**Comanche Peak Nuclear Power Plant, Units 3 & 4
COL Application**

FSAR Revision 3

Update Tracking Report

Revision 0

Figure 1.2-1R Comanche Peak Units 3 & 4 Site Plan (Sheet 2 of 2)

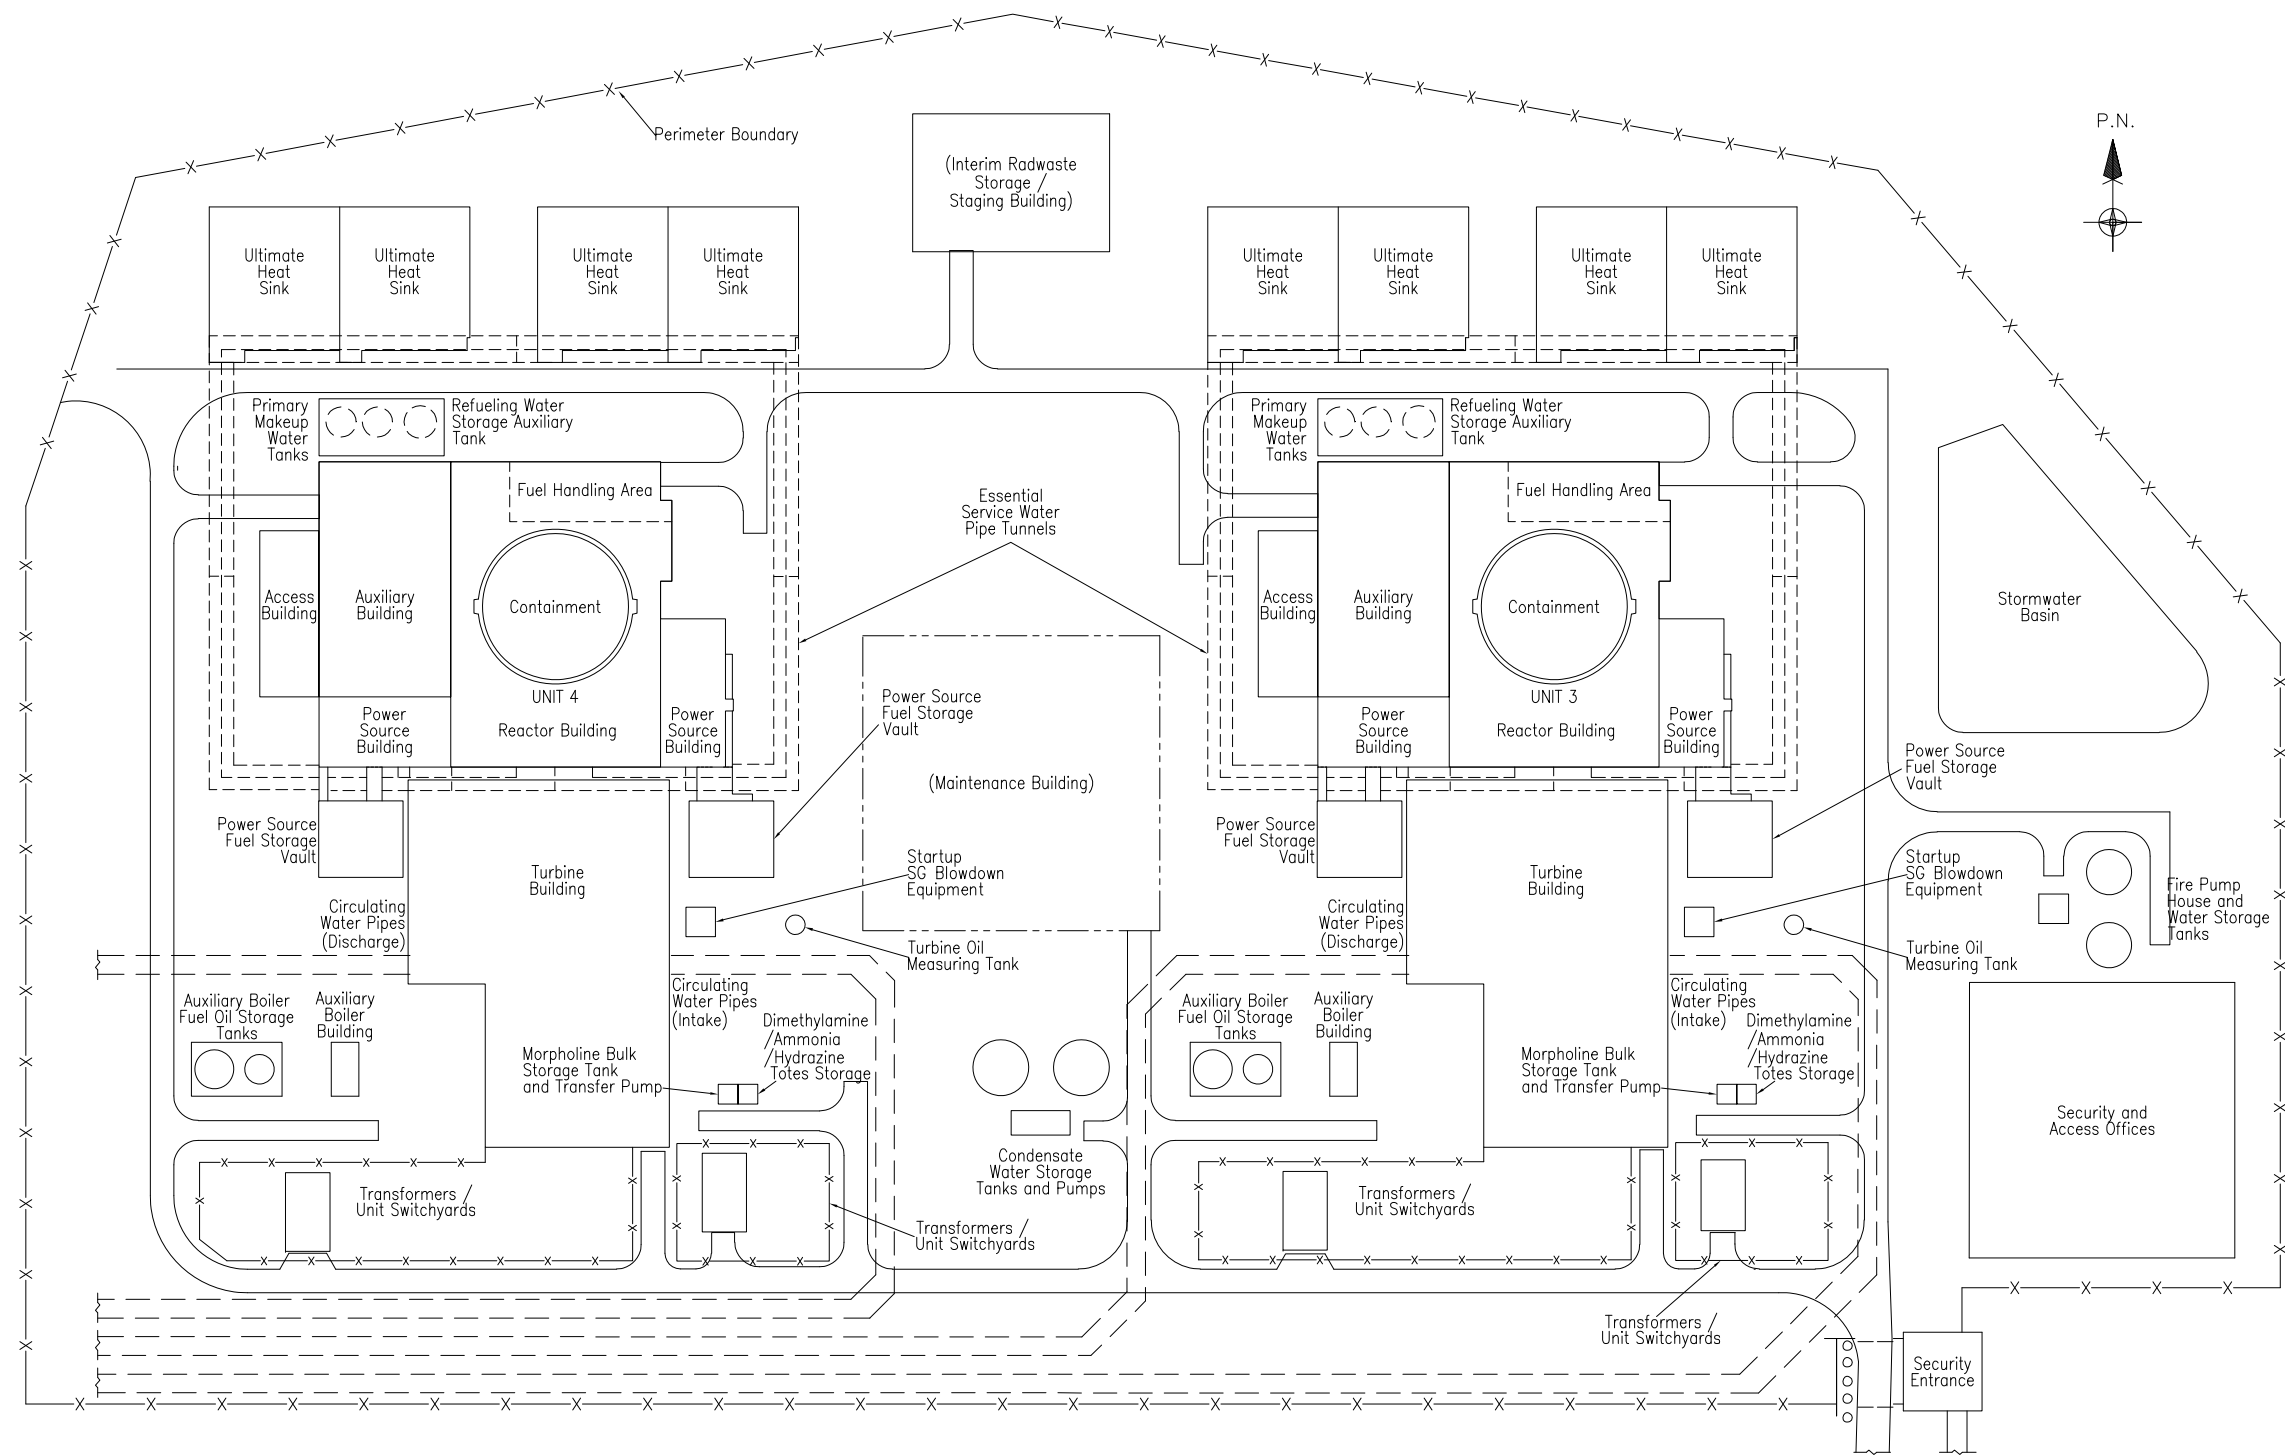
CTS-01506

Figure 2.1-201 Site Plot Plan

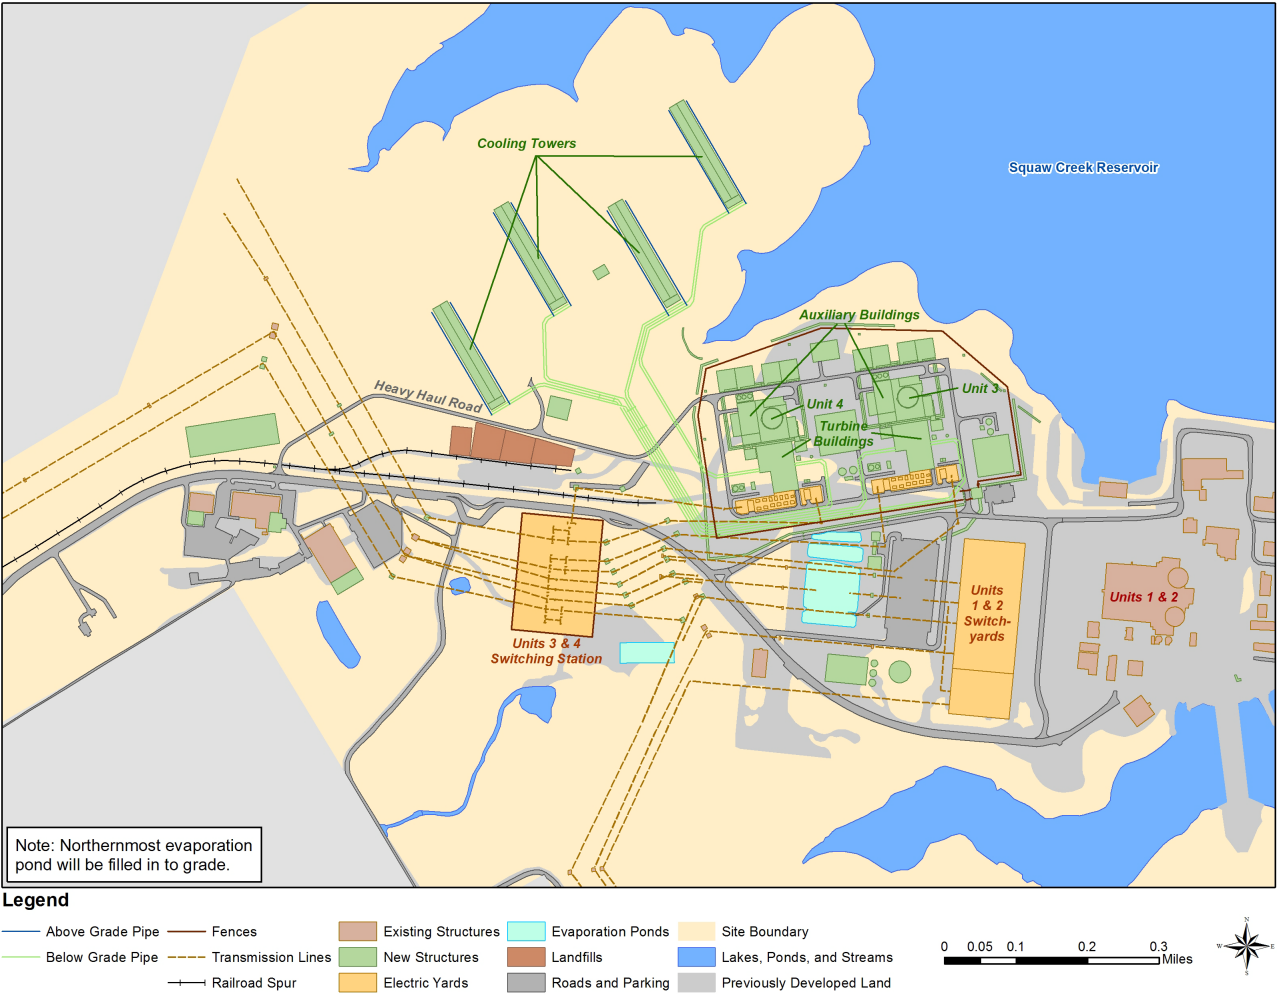
CTS-01513

Figure 2.3-380 Location of CPNPP Meteorological Tower and Plant Structures

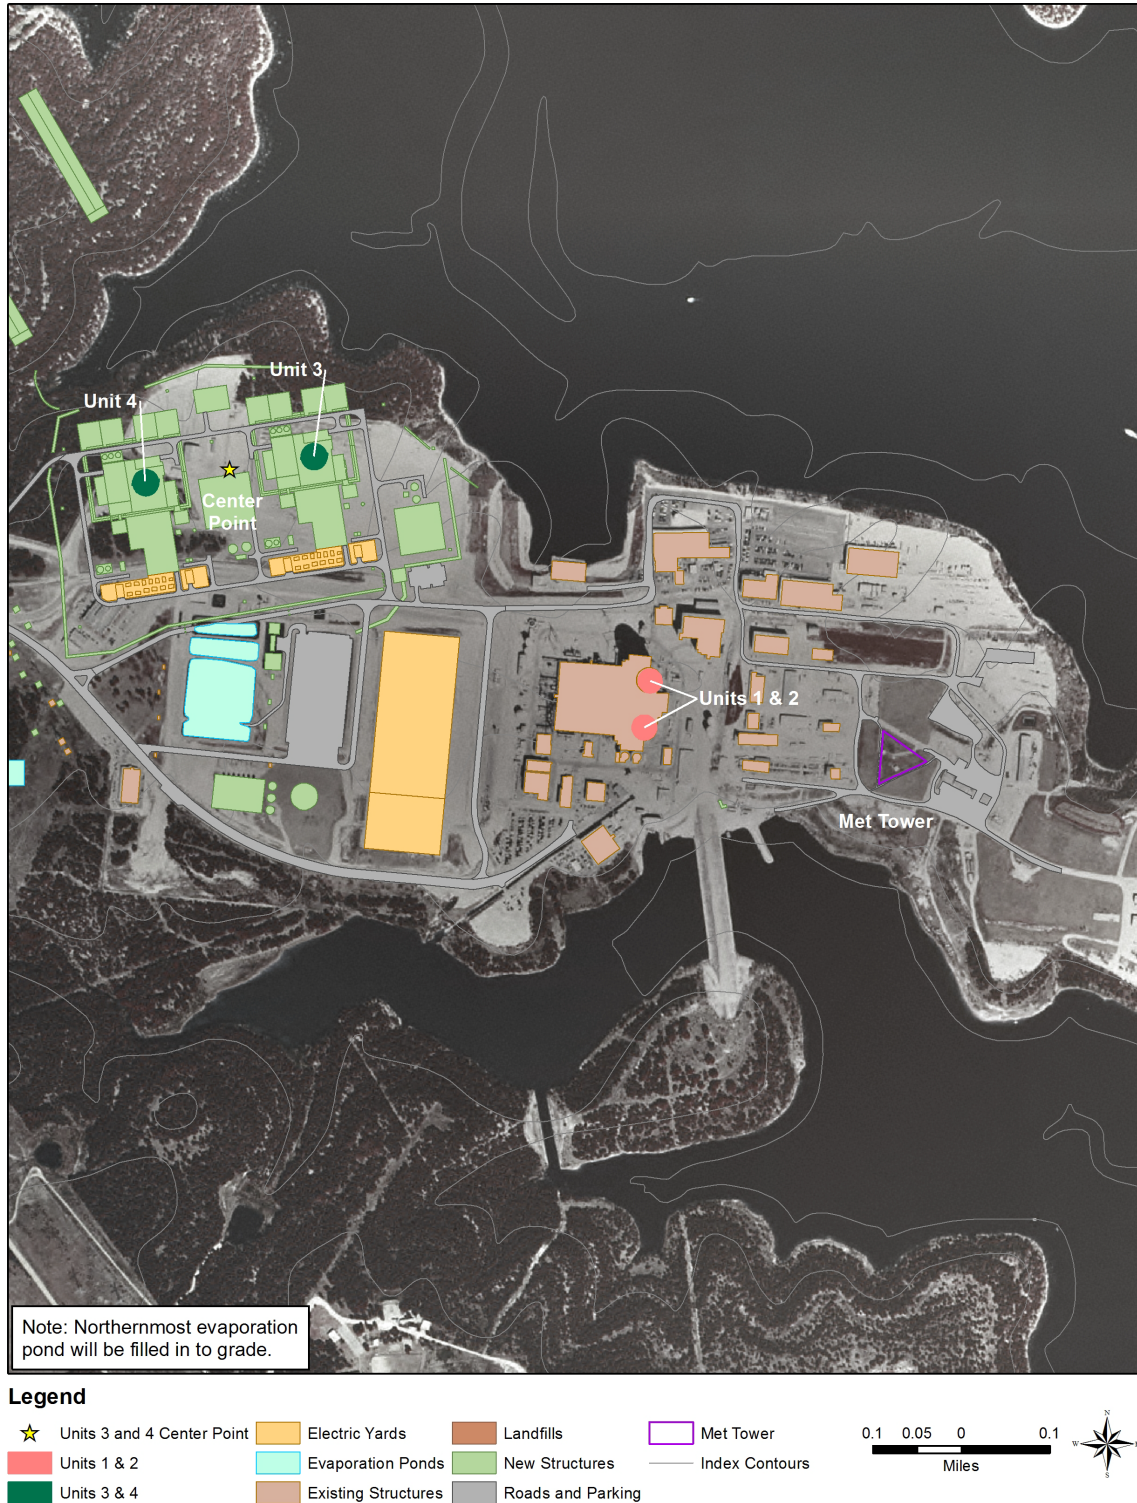
CTS-01513

Figure 9.5.1-202 CPNPP Units 3 & 4 Fire Main System

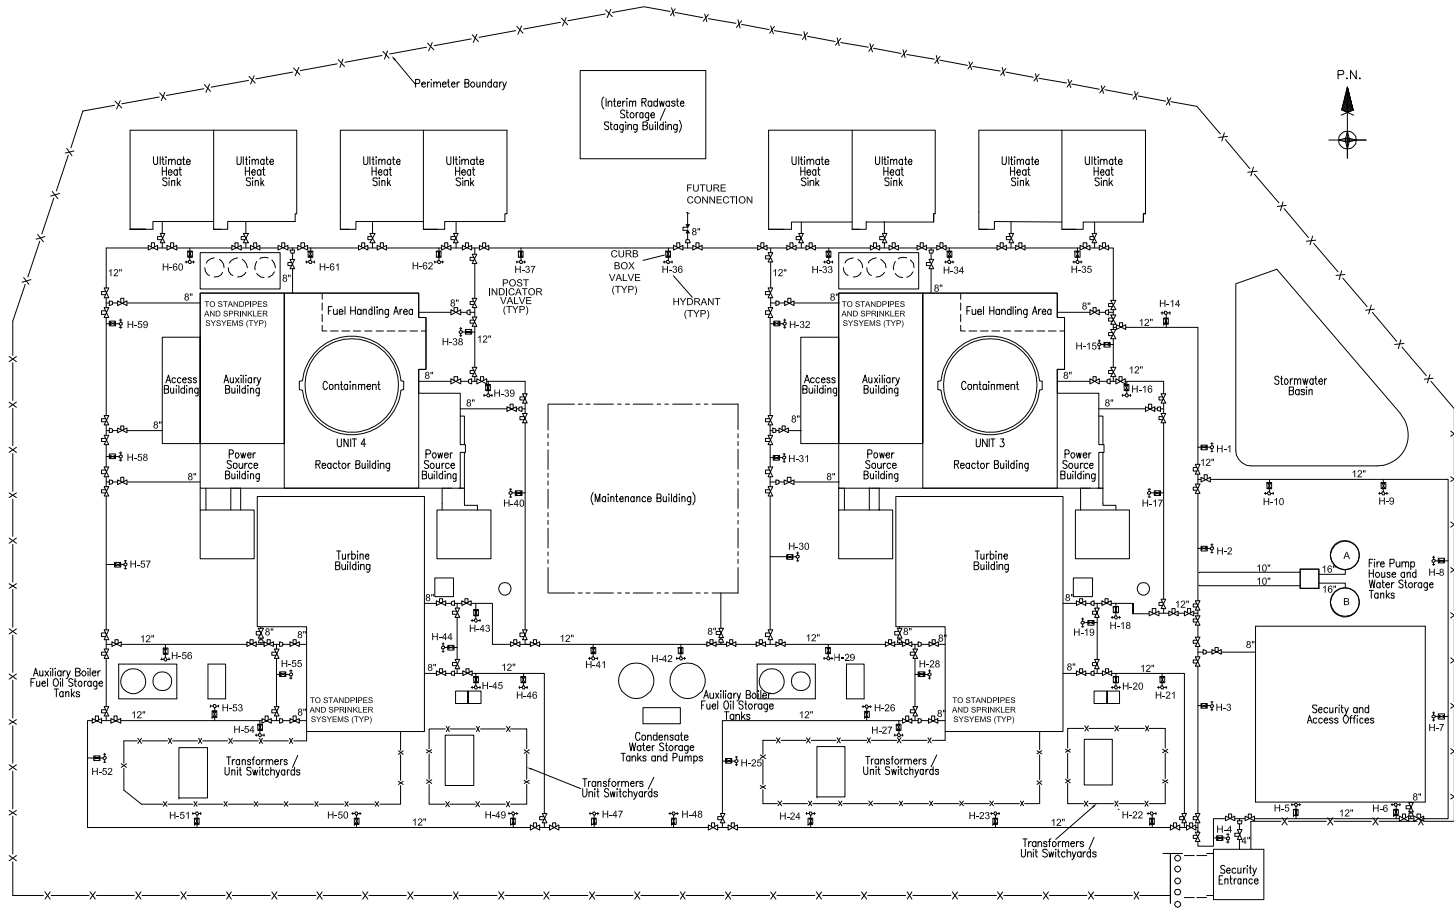
Change ID No.	Section	FSAR Rev. 3 Page	Reason for change	Change Summary	Rev. of FSAR T/R
CTS-01517	Figure 9.5.1-202	9.5-148	Design change as described in Luminant ISCP Letter ML12268A413	Reflected new site plan.	0
CTS-01516	9A.3	9A-1	Correction	Changed "Pumping Station" to "Pump House" in first bullet.	0
CTS-01518	9A.3	9A-1	Design change as described in Supplemental Response to RAI No. 254 (ML12334A026) and the ISCP (ML 12268A413).	Added bullets ESW-Piping Room and UHS-Transfer Piping Room.	0
CTS-01518	9A.3	9A-2	Design change as described in Supplemental Response to RAI No. 254 (ML12334A026) and the ISCP (ML 12268A413).	Changed the DCD Subsection to 9A.3.153.	0

CTS-01517

Figure 12.3-1R Radiation Zones for Normal Operation/Shutdown Site (Sheet 1 of 34)

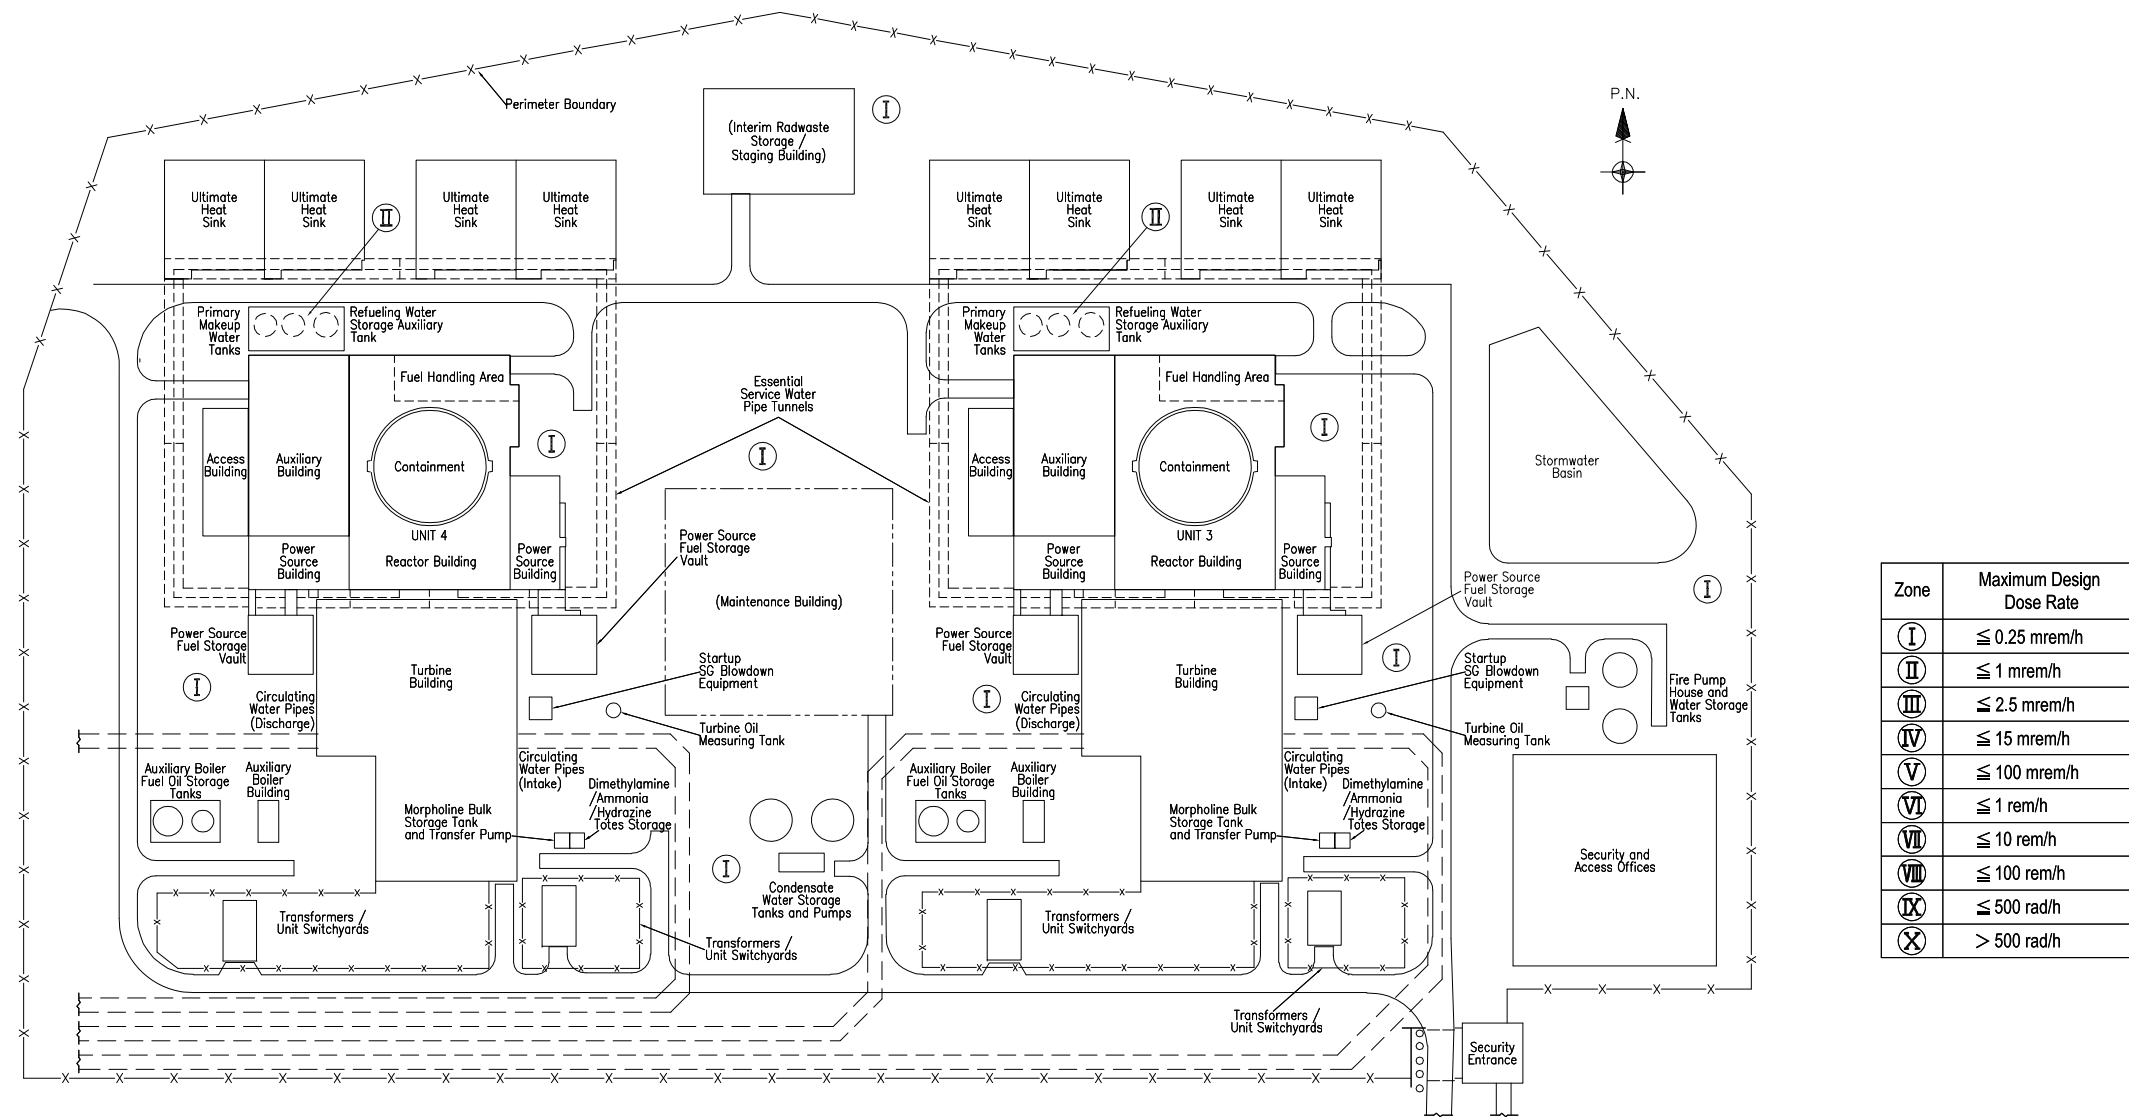
CTS-01510	Figure 12.3-1R (Sheet 1 of 34)	12.3-11	Consistency with DCD as described in Letter. TXNB-12033 (ML12268A413)	Figure was updated to reflect standard plant and site-specific layout changes.	0

CTS-01510
